Access Compliance Report Public Rights-of-Way (Curb Ramps)

Main Street: JOSHUA_LN Cross Street: CARLSBAD_DR Location: SW

ADA ID: RPAT211019103928 Ramp Type: Type 1 - Perpendicular Diagonal Initial Pass/Fail: Pass Overall Compliance: No Severity Score: 16

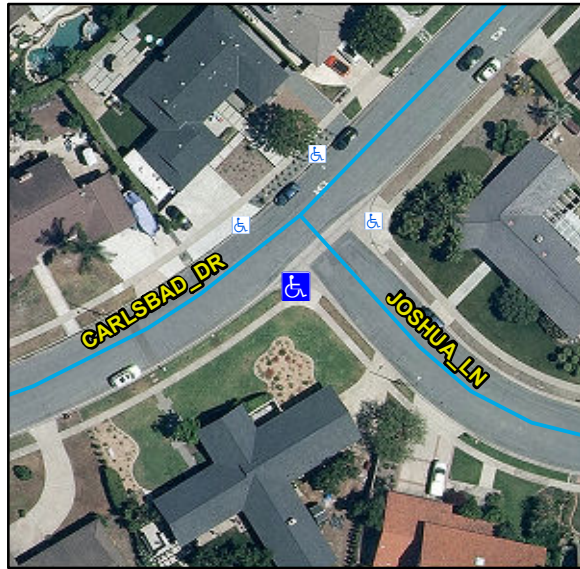
Compliance	Description	Data	Compliance	Description	Data
N/A	Ramp Length (in)	75	N/A	Flare Type LT	
Yes	Ramp Width (in)	55			Sloped
Yes	Ramp Run Slope (%)	6	N/A	Flare Slope LT (%)	5.2
Yes	Ramp Cross Slope (%)	1.3	N/A	Flare Traversable LT	No
N/A	Landing Present	Yes	N/A	Flare Type RT	
N/A	Landing Length (in)	40			Sloped
Yes	Landing Width (in)	55	N/A	Flare Slope RT (%)	3.9
No	Landing Run Slope (%)	3.9	N/A	Flare Traversable RT	No
No	Landing Cross Slope (%)	2.4	No	DWS Provided	No
N/A	Landing Movement Obstructed?	Yes	N/A	DWS Contrast	N/A
	Landing Movement Type	Curb	N/A	DWS Length (in)	N/A
N/A	Landing Shared	No	N/A	DWS Full Width	N/A
N/A	Clear Space	Yes	N/A	DWS Offset Left (in)	N/A
N/A	Clear Space To Crosswalk (in)	48	N/A	DWS Offset Right (in)	N/A
N/A	Marked Crosswalk 1	No	N/A	Marked Crosswalk 2	No
	Crossing 1 Direction	NE		Crossing 2 Direction	NW
	Marked Crosswalk 1 Width (in)	N/A		Marked Crosswalk 2 Width (in)	N/A

N/A	Ramp Inside Crosswalk 1	N/A	Yes	Ramp Inside Crosswalk 2	N/A
	Crossing 1 Slope (%)	2.4		Crossing 2 Slope (%)	4.9
	Crossing 1 Cross Slope (%)	3		Crossing 2 Cross Slope (%)	0.8
Yes	Gutter Ponding	No	No	Curb Slope	10.8
Yes	Gutter Lip Height (in)	0		Road Run Slope (%)	0.9
Yes	Gutter Run Slope (%)	3.5		Road Cross Slope (%)	0.7
Yes	Gutter Cross Slope (%)	1.3			
Yes	Overall Surface Condition: Acceptable		No	Perp Joint Present	No
	Cross Gutter Present?	Yes		Spandrel Present?	Yes
	Replace Cross Gutter?	No		Replace Spandrel?	No

Remove & Replace Curb Ramp With Two New Directional Ramps or Equivalent.
